# AEBS HDV IWG

Industry Questions and Comments  
to JAPAN presentation of Nov.9, 2020  
(ref. AEBS-HDV-01-02)

AEBS-HDV-SP-02  
January 25-27, 2021

slide 2

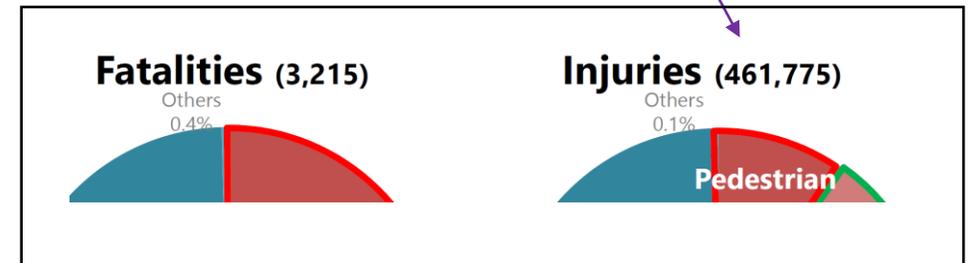
Consistency between this slide and slide 5:

- Slide 2: ~457,000 in 2019
- Slide 5: 461,775 in 2019

slide 3

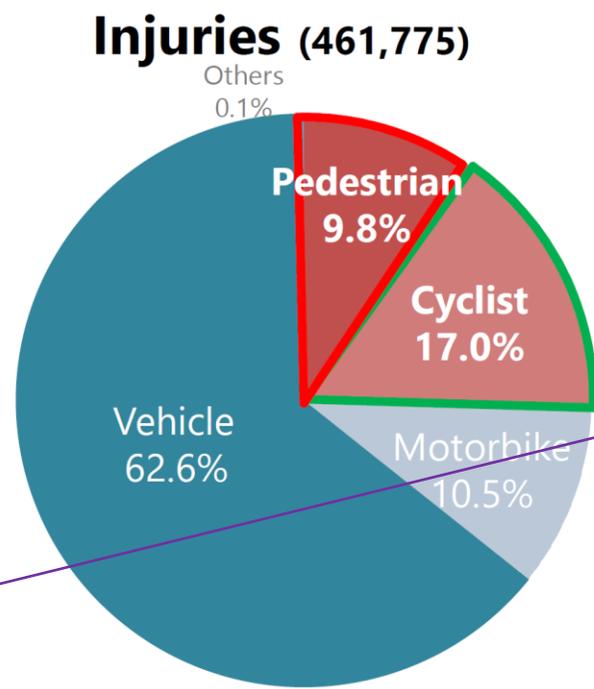
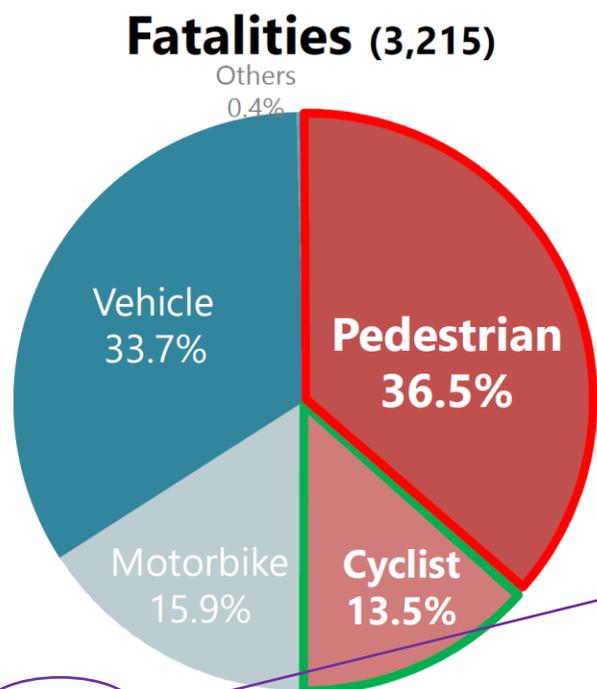
These graphics are a good introduction but are not sufficient to demonstrate the need for a city-AEB.

For that we would need a breakdown of the pedestrian and cyclist accidents, with an analysis of the accident cause relevant for an AEB.

Advantageous, because very new data from 2019 is used, unlike slides 5, 6, 7 and 8 which are based on data from 2016. Could updated sources from 2019 be used on all slides, to be able to synchronize the data all over the presentation?

## Fatality rate by vehicle category

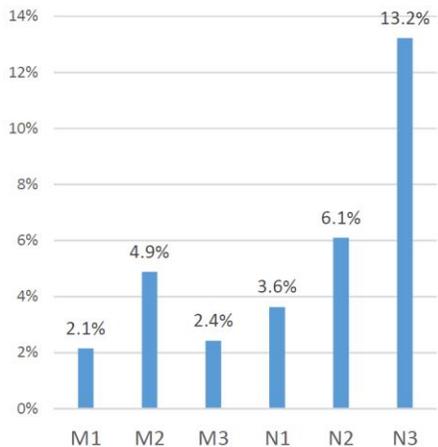
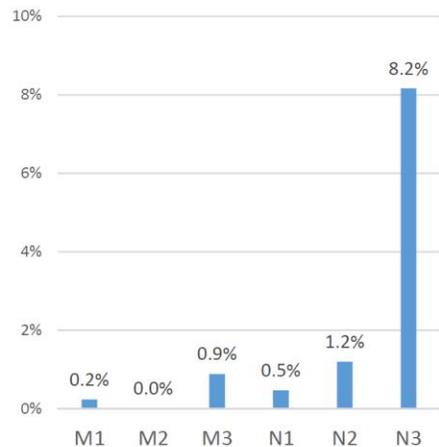
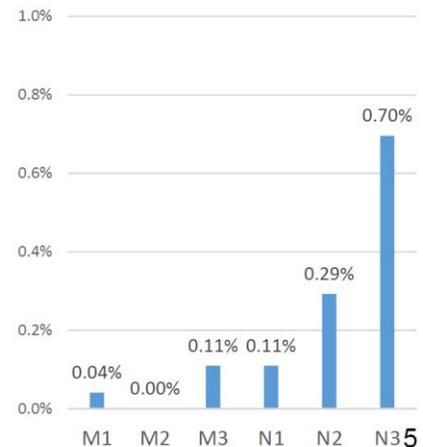
Industry is keen to know what values of “all injury cases” are considered in each of the graphs below. We would then be able to calculate the frequency of fatalities of collisions with:

- Pedestrians
- bicycles
- cars... for each vehicle category.

such absolute values of fatalities would permit assessing the magnitude of the problem in Japan.

A further breakdown of the accidents looks necessary in order to assess the efficiency of the AEBS with regard to the accident frequencies:

- what is the share between: Front accidents; Turning situation; lateral/side collisions; crossing scenarios; Rear end?
- Area of accidents: urban, interurban, countryside...?
- Speed ranges ?

The source data is from 2016. Updated sources from 2019 would permit to synchronize the data with slide 4

slide 6

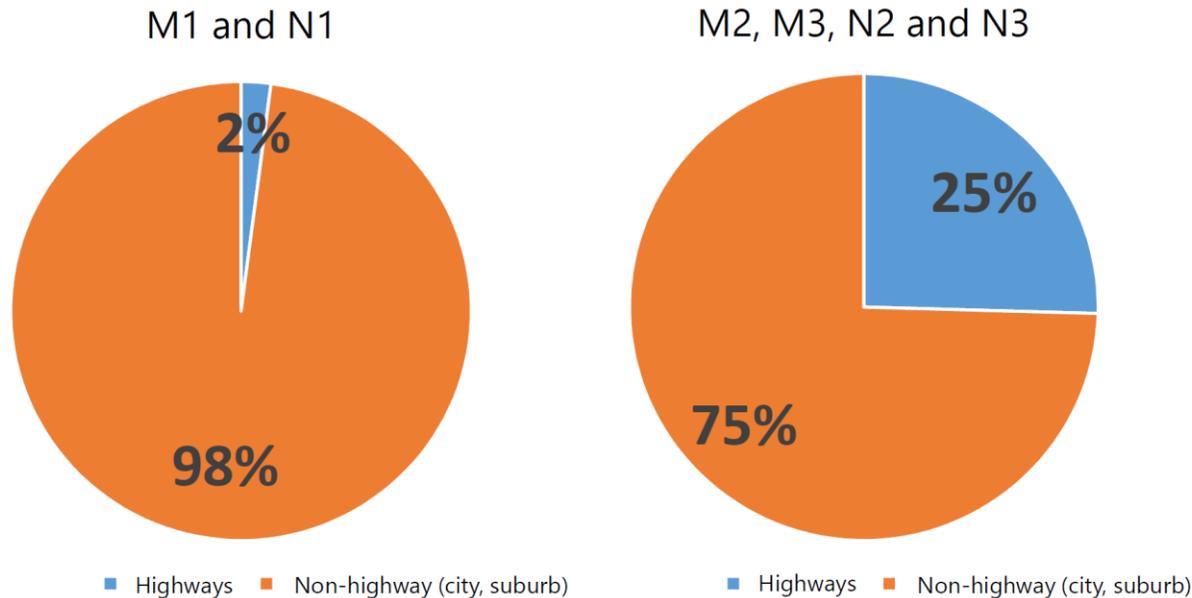
What do the percentage values mean in absolute fatalities figures?

How many accidents on passenger cars compared to CVs ?

Further breakdown is needed:

- what is the share between: Front accidents; Turning situation; lateral/side collisions; crossing scenarios; Rear end?
- Area of accidents: urban, interurban, countryside?
- Speed ranges?

The source data is from 2016. Updated sources from 2019 would permit to synchronize the data with slide 4

slide 9

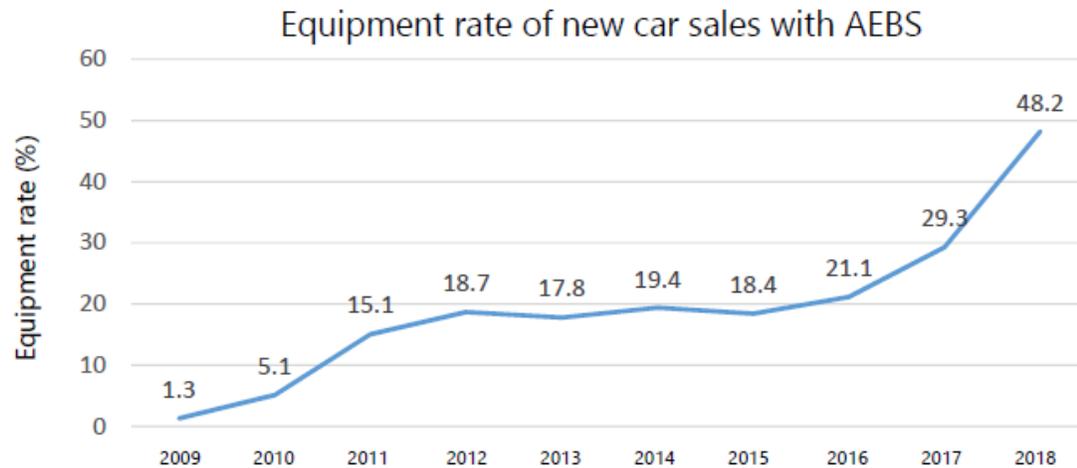
This chart shows the state of the art and market penetration of AEBS on passenger cars.

Passenger cars and CVs have different vehicle dynamics, usage, sensors installation... Passenger cars AEB strategies cannot be copy-pasted on HCVs, with the same expected level of efficiency or driver acceptance.
